**First Five-Year Review Report for the
Building 850/Pit 7 Complex Operable Unit at
Lawrence Livermore National Laboratory
Site 300**

April 2016

Environmental Restoration Department

Figure 4. Building 850 and Pit 7 Complex area ground water potentiometric surface map for the Qal/WBR hydrostratigraphic unit, 4th Quarter 2014.

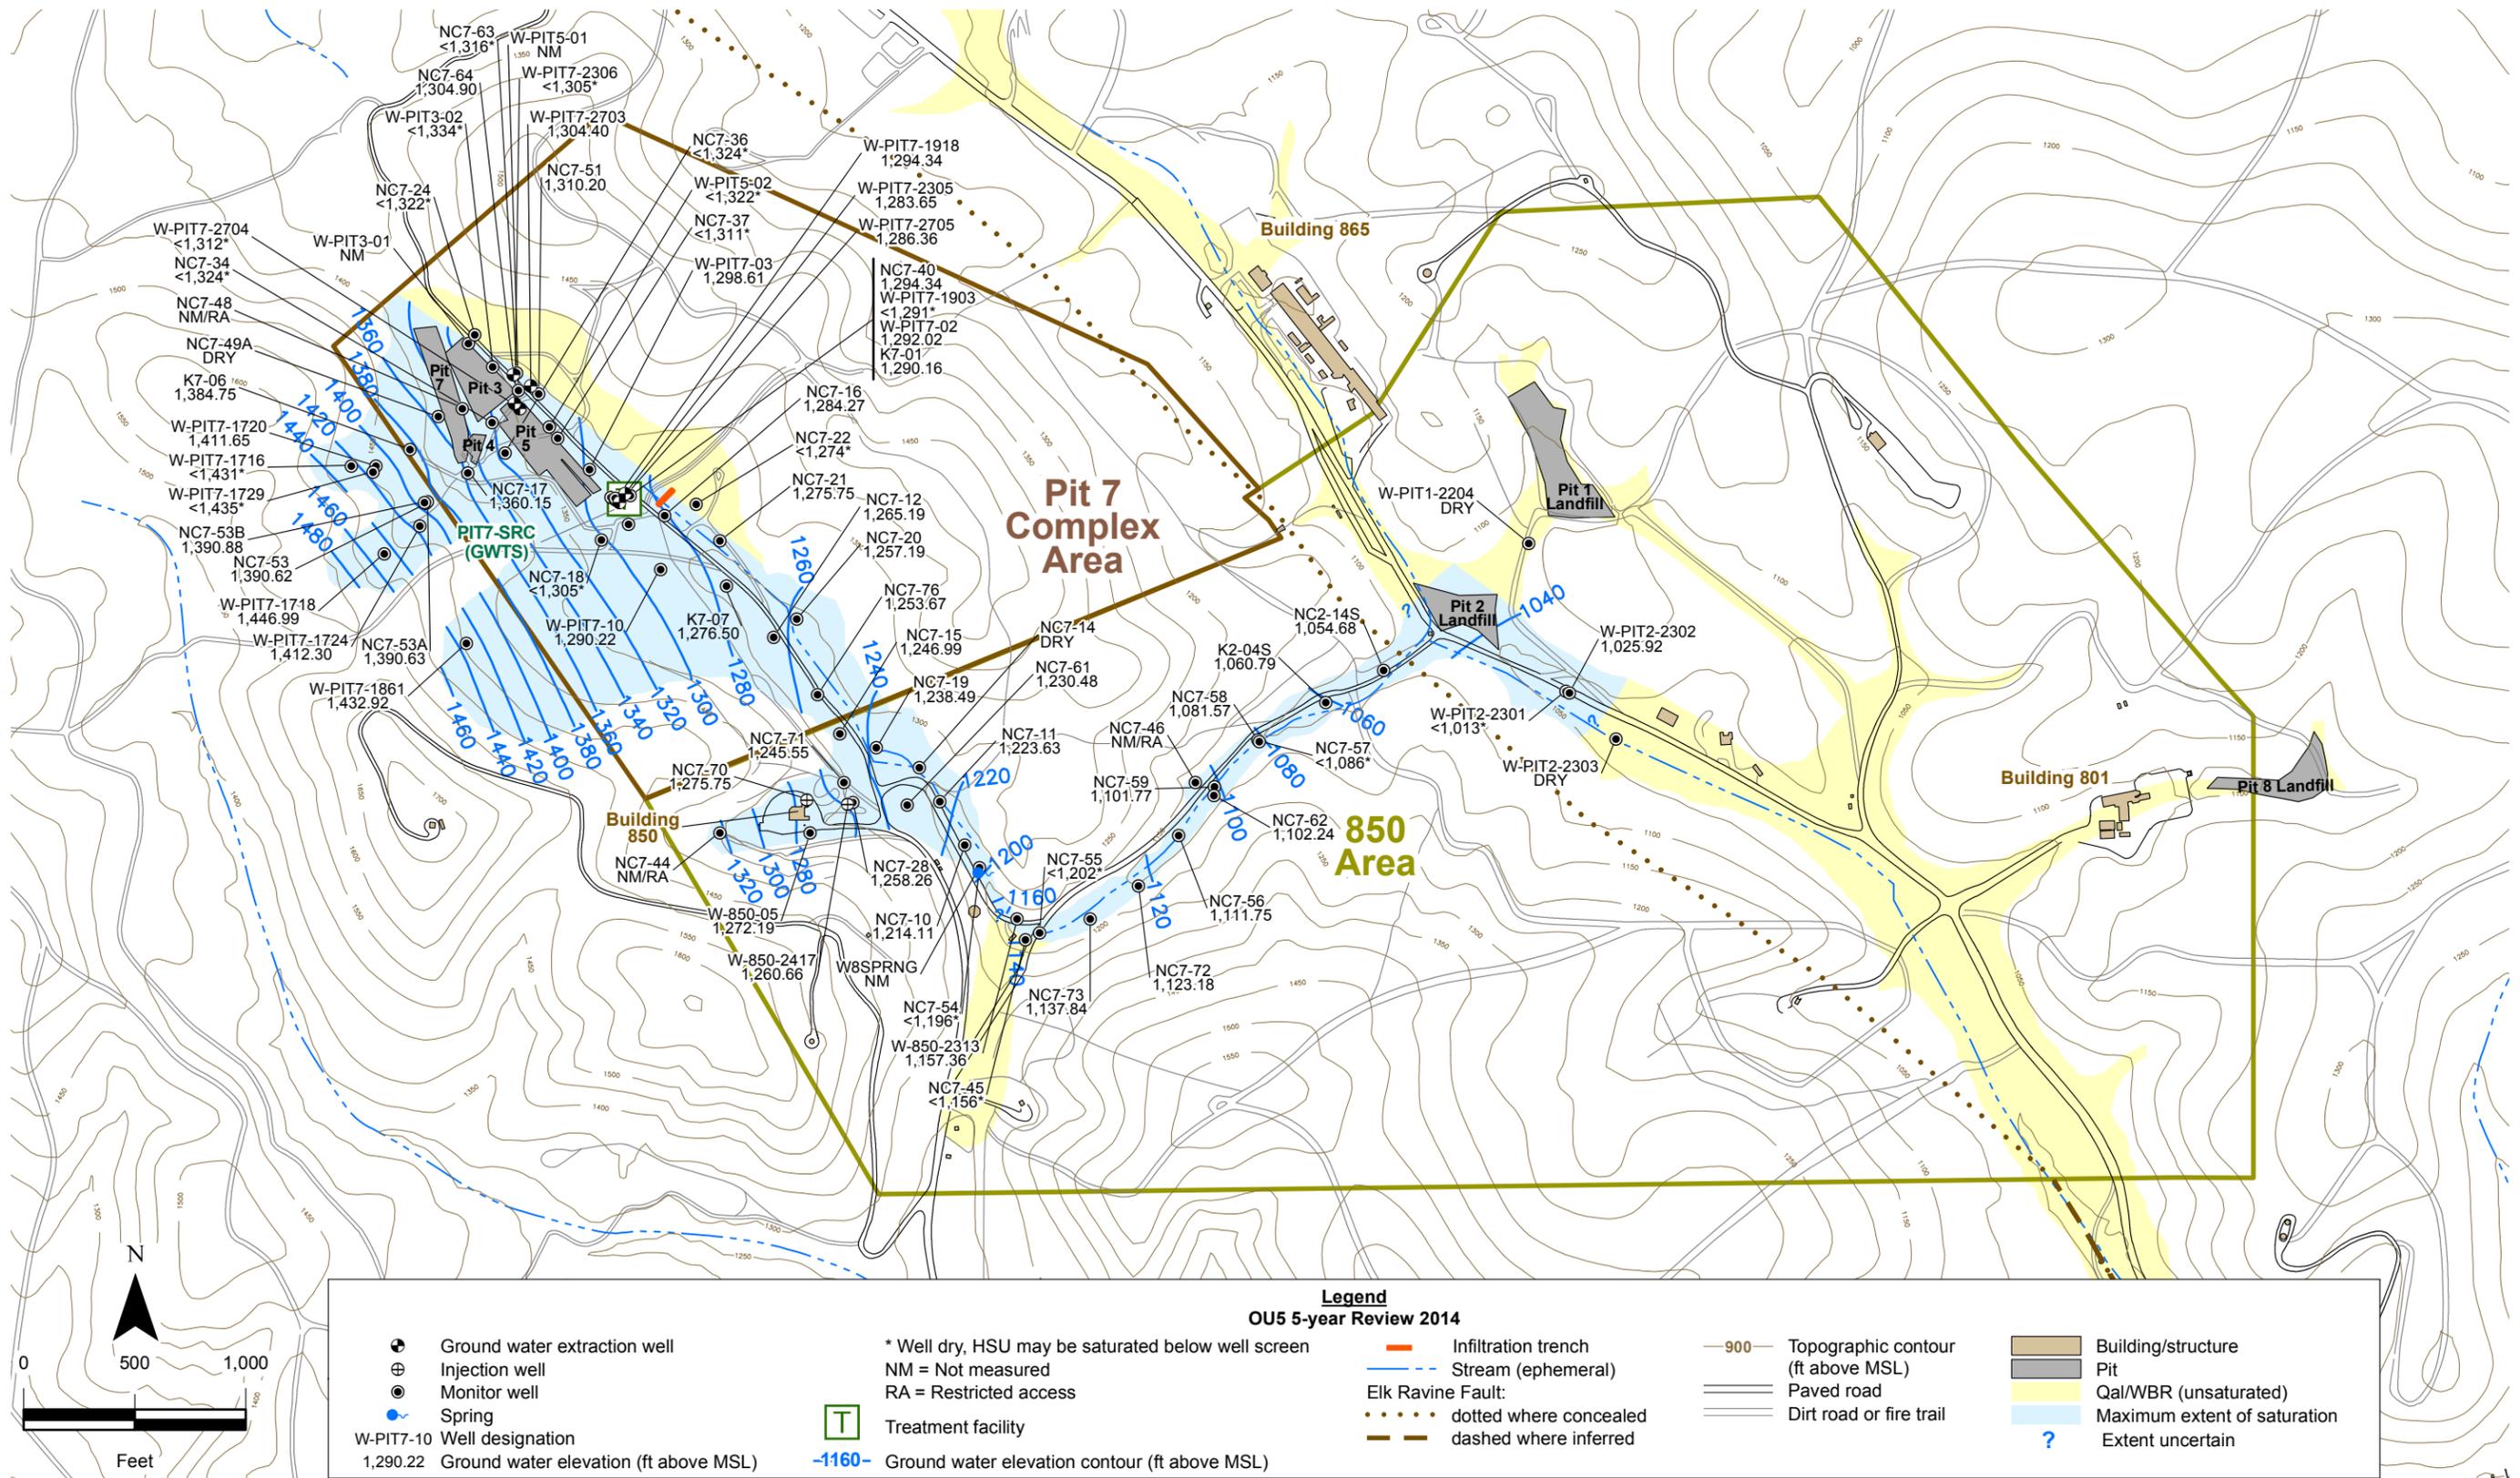
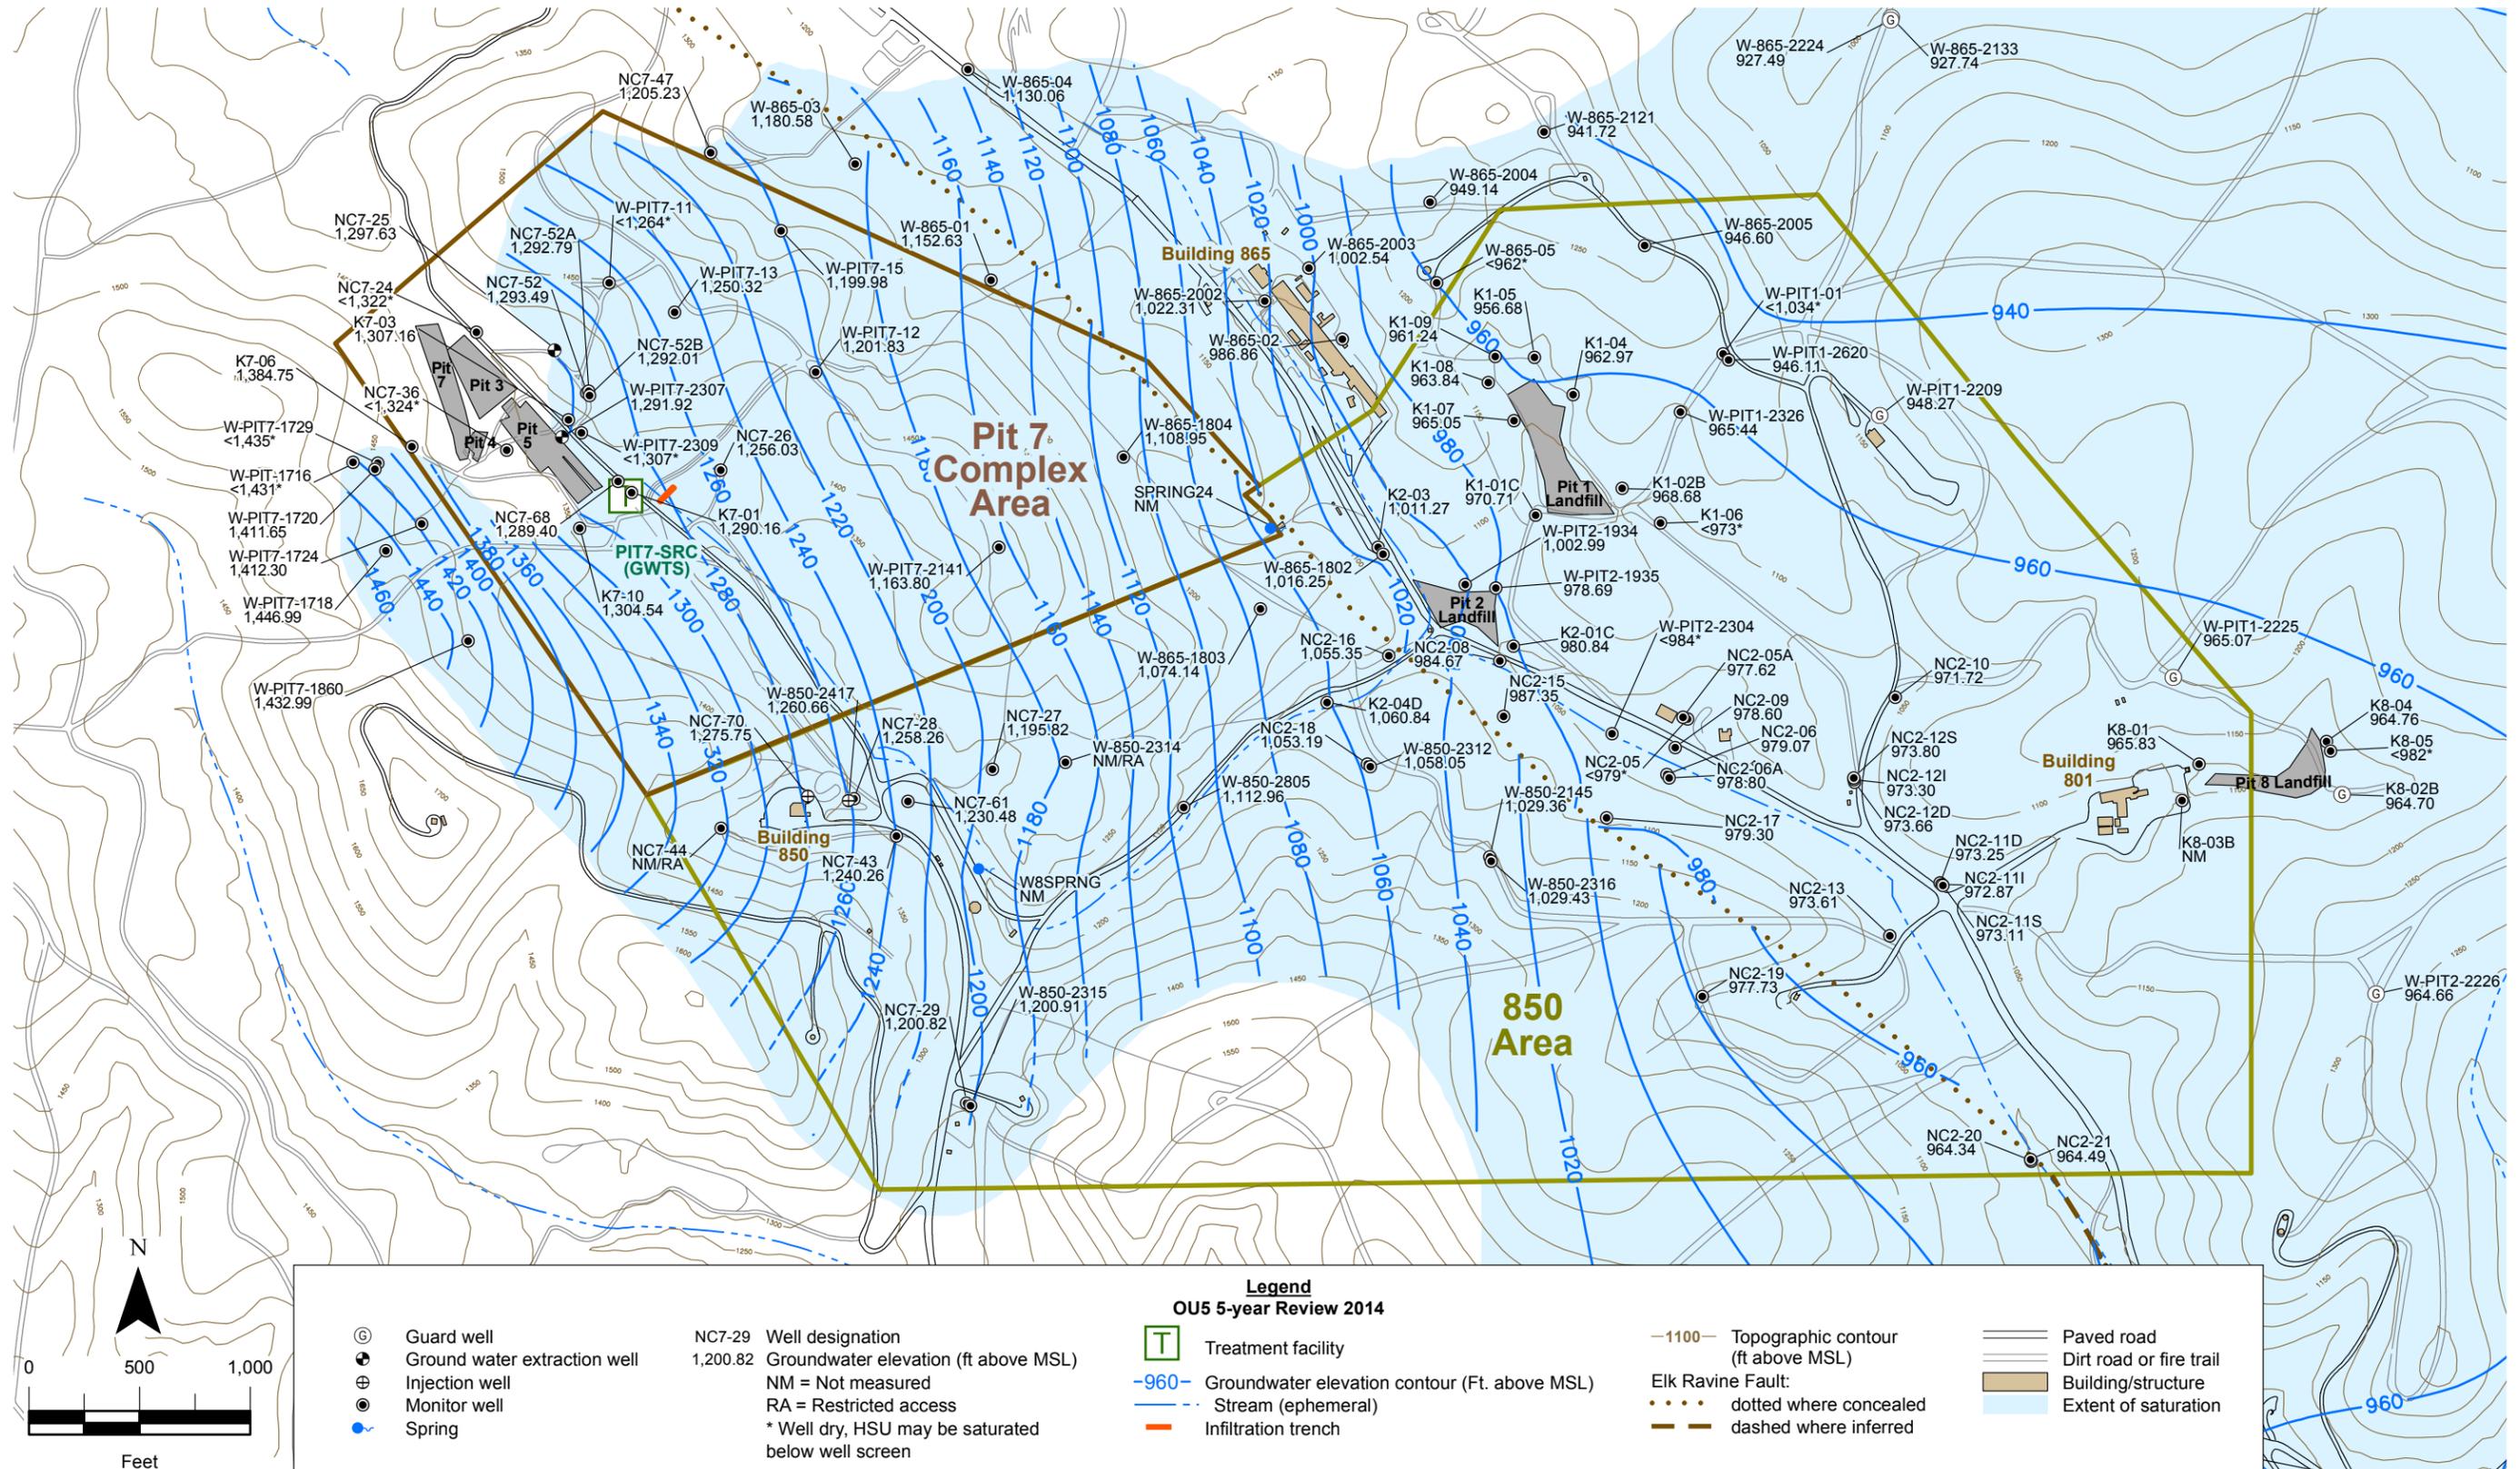
22. **Figure 4, Building 850 and Pit 7 Complex area ground water potentiometric surface map for the Qal/WBR hydrostratigraphic unit and Figure 5, Building 850 and Pit 7 Complex area ground water potentiometric surface map for the Tnbs₁/Tnbs₀ hydrostratigraphic unit:** The date(s) when the water level measurements were made are not provided on Figures 4 or 5. Please revise Figures 4 and 5 to include the date(s) when the water level measurements were made.

Response: The water level measurements used to construct Figures 4 and 5 were collected during the fourth quarter 2014. To address the comment, the words “4th Quarter 2014” have been added to the ends of the captions of Figures 4 and 5.

3. The Report states that well NC7-29 is located cross-gradient of Building 850. Regional Water Board staff's interpretation of the groundwater potentiometric map shown on Figure 5 is that well NC7-29 is located downgradient of Building 850. Please provide the rationale for concluding that NC7-29 is located cross-gradient and not downgradient of Building 850.

Response: DOE/LLNL's conclusion that NC7-29 is located cross-gradient and not downgradient of Building 850 is based on the potentiometric surface contours shown on Figure 5 that indicate ground water flow from Building 850 is in a west to east flow direction (perpendicular to the potentiometric surface contours). Well NC7-29 is located about 1,500 ft southeast of Building 850 in a location that can only be defined as cross-gradient based on the potentiometric surface contours.
